STAFF RECOMMENDATION
1502 Cedar Lane
December 18, 2019

Application: New Construction—Addition; Partial Demolition
District: Belmont-Hillsboro Neighborhood Conservation Zoning Overlay
Council District: 18
Base Zoning: R8
Map and Parcel Number: 11704030400
Applicant: Matthew McCrary, Allard Ward Architects
Project Lead: Melissa Baldock, melissa.baldock@nashville.gov

Description of Project: The applicant proposes to construct a rear addition that is wider than the historic house. The application also involves removing an existing rear addition, side patio, and columns, and altering window and door openings, which is considered partial demolition.

Figures 7 & 8 show the door and window opening that will be altered into paired window openings.

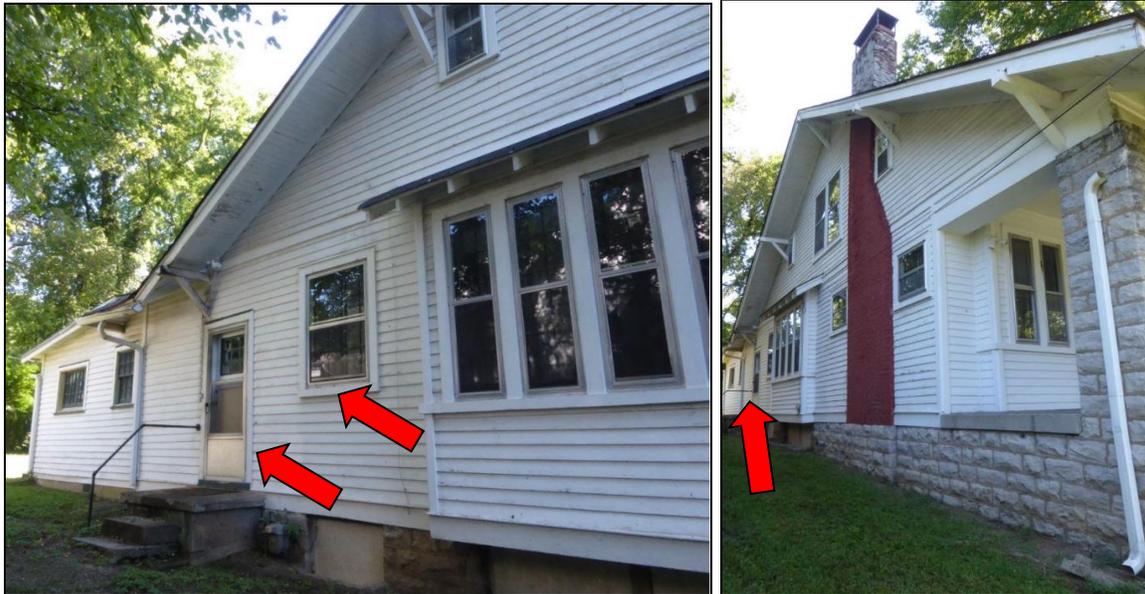
On the left façade, at the back of the historic house, the applicant intends to change a door opening into a paired window opening, and to slightly alter the size of a window opening to its right (Figures 7 & 8). Staff finds these changes to be appropriate because they are located at the back of the historic house, where they will not be highly visible from the street.

Figures 9 & 10 show the alterations of the window and door openings on the back half of the right façade.

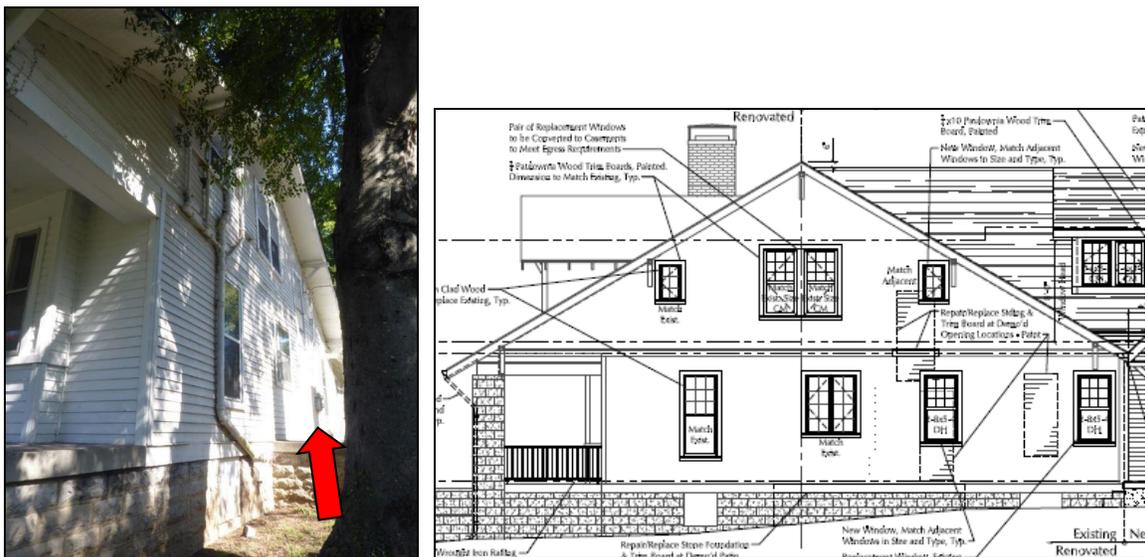
On the right façade, the applicant is planning to alter several window openings in the back half the house (Figures 9, 10). This includes removing a door opening between the first and second floors that is no longer accessible and shifting a window at the very back of the house. It is clear on this façade that the window and door openings have been altered over the years. Because the openings are in the back half of the house, not highly visible from the street, staff finds them to be appropriate.

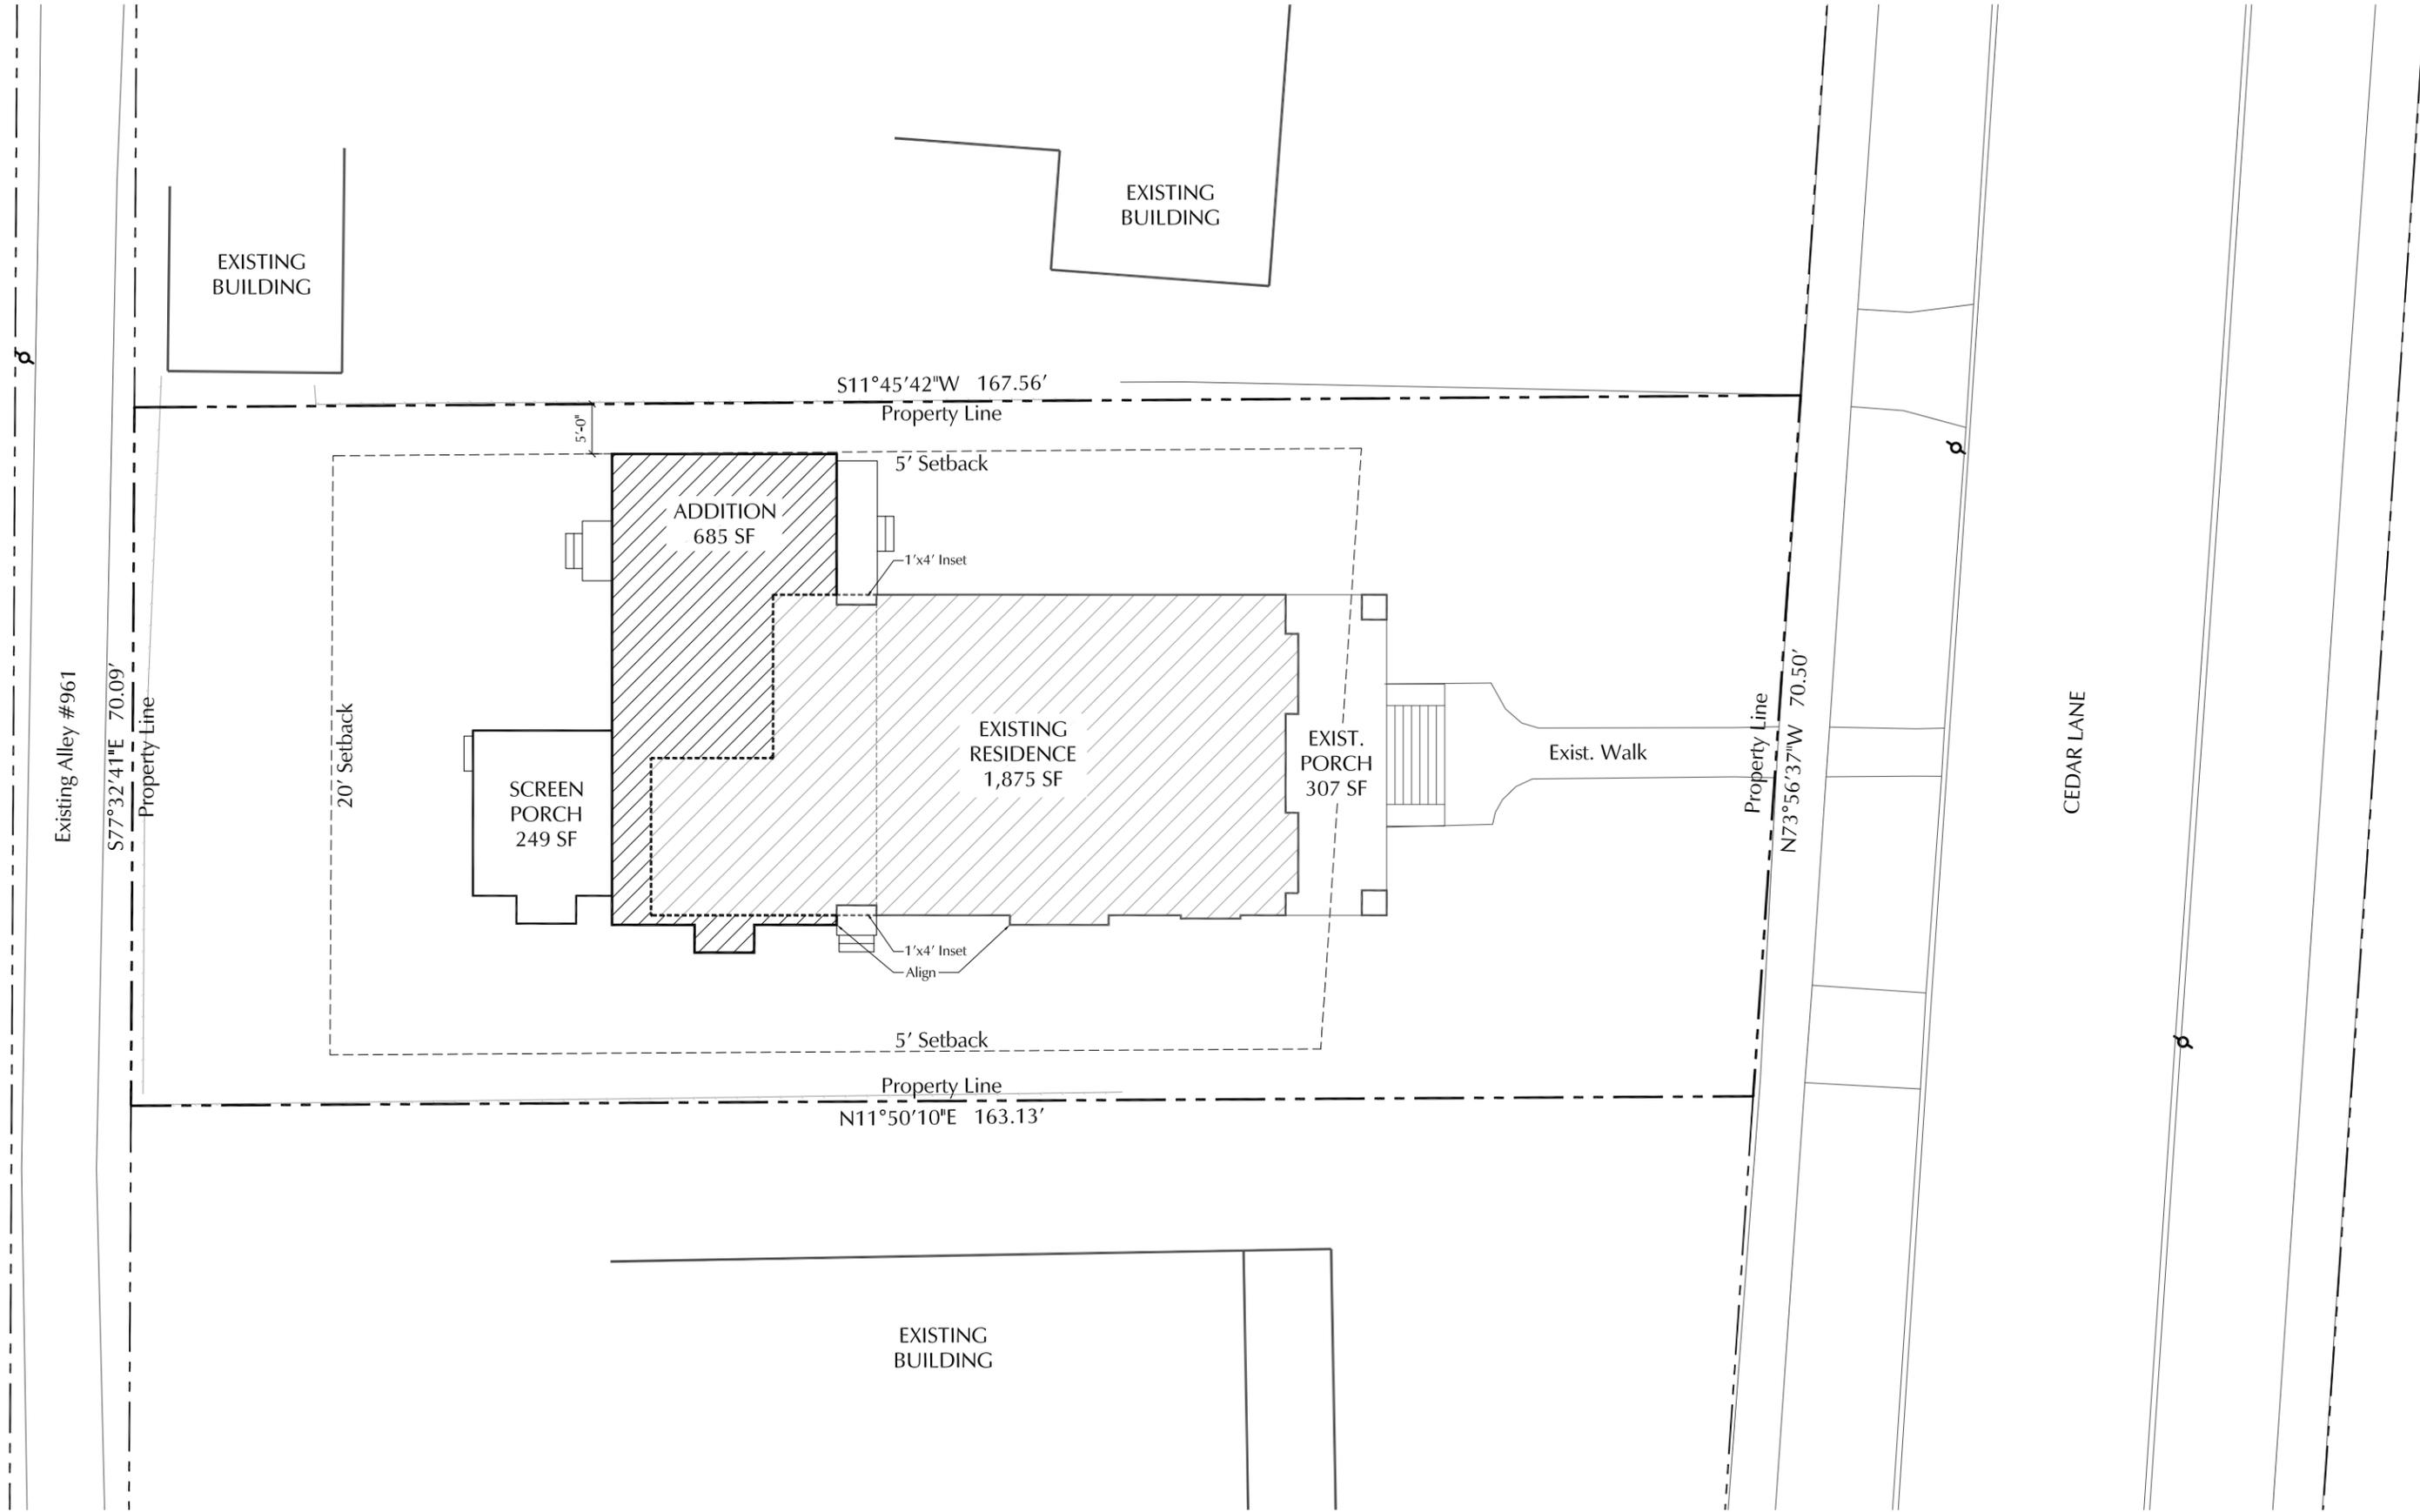
Proportion and Rhythm of Openings: The changes to the window and door openings on the historic house are discussed under “Partial Demolition.” The windows on the proposed addition are all generally twice as tall as they are wide, thereby meeting the historic proportions of openings. There are no large expanses of wall space without a window or door opening.

Staff finds the project's proportion and rhythm of openings to meet Sections II.B.1.g. and II.B.2 of the design guidelines.

Demo: First Floor Plan

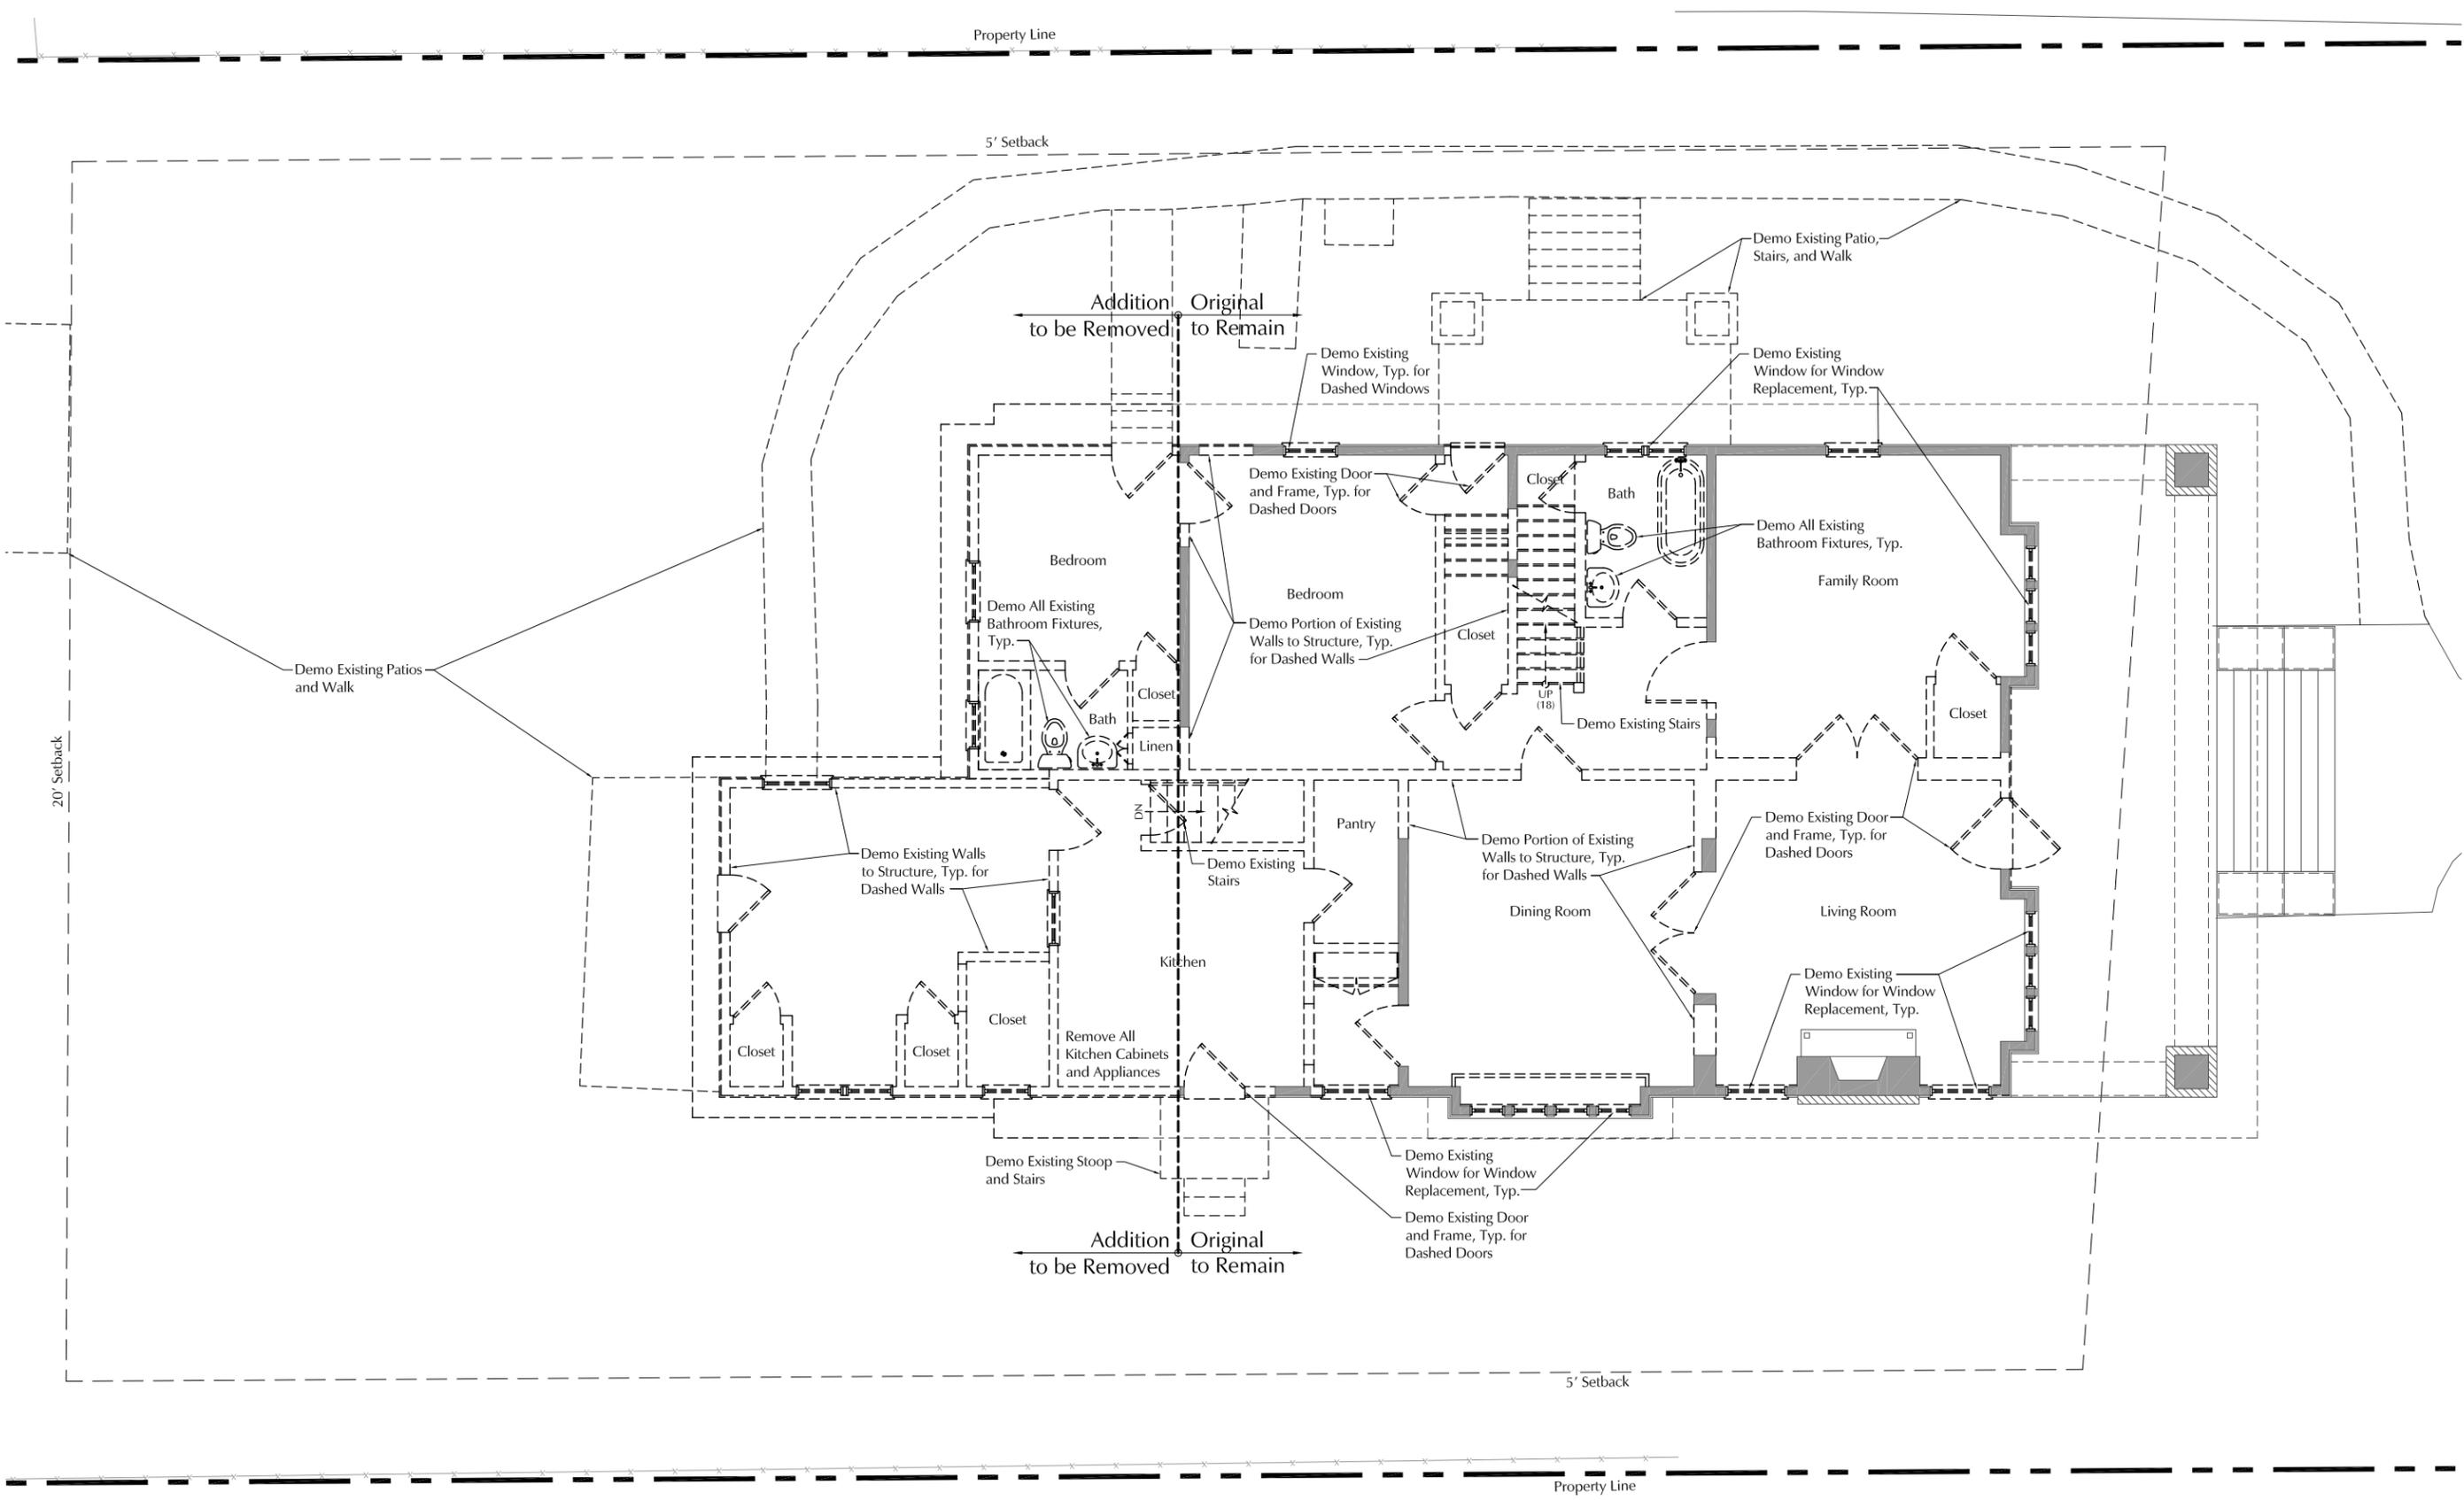
Partial Demolition: The applicant proposes several changes to the historic house, which are considered partial demolition. First, the applicant proposes to demolish an existing rear addition (Figure 2). The date of construction of the existing rear addition is not known, but it does not appear on the 1950s Sanborn maps (Figure 3). Staff finds that the rear addition's date of construction, roof form, and overall design do not contribute to the historic and architectural character of the historic house and finds its removal to be appropriate.

The applicant also proposes to remove a side patio and columns (Figures 4 & 5). It is not clear if the side patio and columns are original to the house or if they ever had a roof on them. The patio is not shown on the 1950s Sanborn maps, and if it had a roof at that time, it should be on the maps. The design of the side porch is unusual, and staff finds it likely that it is not original to the house. In addition, technically, the Commission does not review uncovered patios and decks in neighborhood conservation zoning overlays like this one. Staff therefore finds that the removal of the side patio and columns is not an action MHZC needs to review.
